**Re: Independence Road Reconstruction Phase 3**

**CONTRACT ADDENDUM #1**

Independence Road Reconstruction Phase 3  
STP-7302-645

Exhibit B

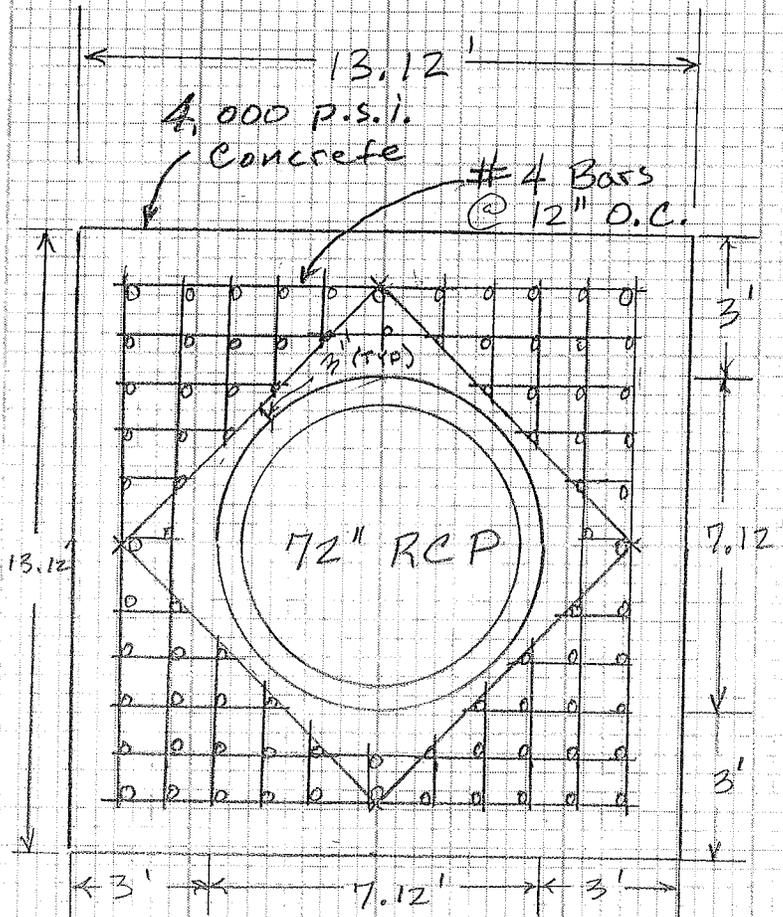
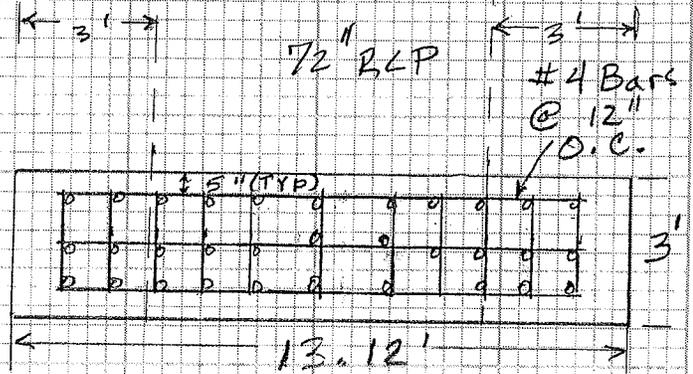
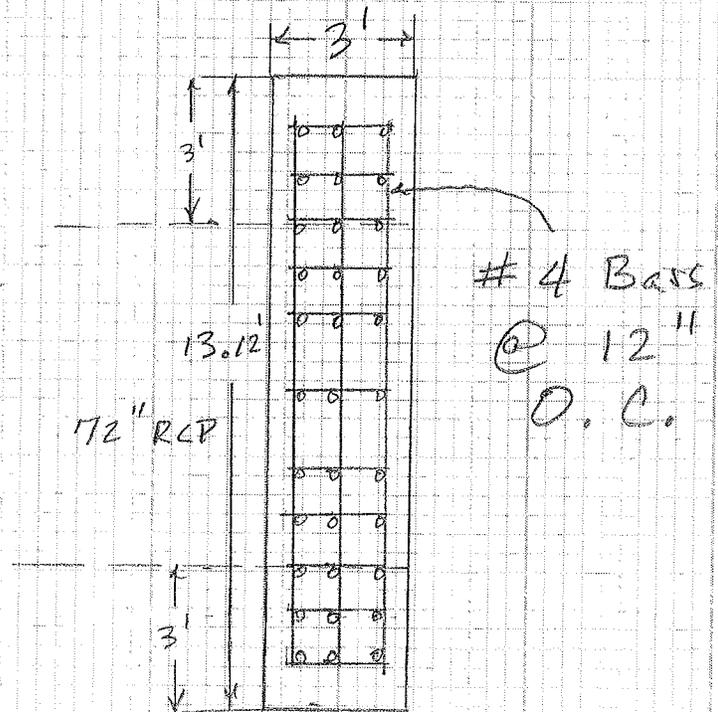
- 24) A landscaping Bid Item has been added for the landscape berm on Parcel 1 that does not include any plants.
- 25) The top elevation for storm structure CI 16 should be lowered to 573.47 as shown on the profile.
- 26) Storm structure AI 36 connects to an existing storm sewer, the flared end it to be removed and the new inlet constructed..
- 27) Existing storm structure MH 33 top is to be lowered, the existing storm sewer flowing in is to remain, and the existing storm sewer out to be removed and replaced.
- 28) A detail for the headwalls has been added on Exhibit B.
- 29) A Bid Item has been added for Rock Ditch Checks.
